E7907A-01

S E R V I C E N O T E

E7907A 2 Port OC3 ATM/POS Router Tester Module

Figure 1: Position the card so that the jumper can be identified.

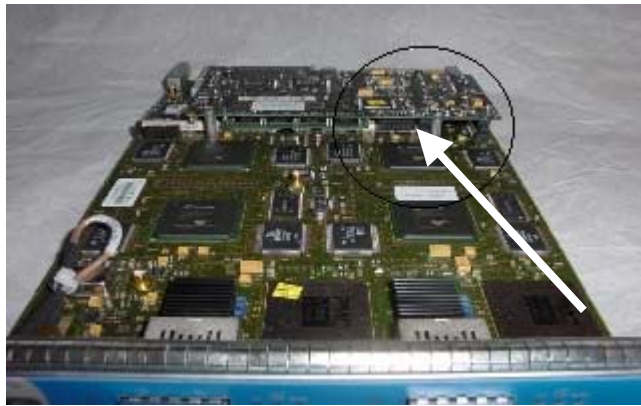
E7907A RouterTester modules were shipped with jumper P4 installed when this should have been permanently removed

The module will occasionally lock up or reboot at random times

Permanently remove jumper P4 from the CPU card

1. Remove the interface from the chassis.
2. Position the interface so that you can locate the jumper on the CPU, as shown in figure 1.
3. Locate the jumper on the CPU card, as shown in figure 2.
4. Remove the jumper from the CPU card, as show in figure 3.
5. Reinstall interface
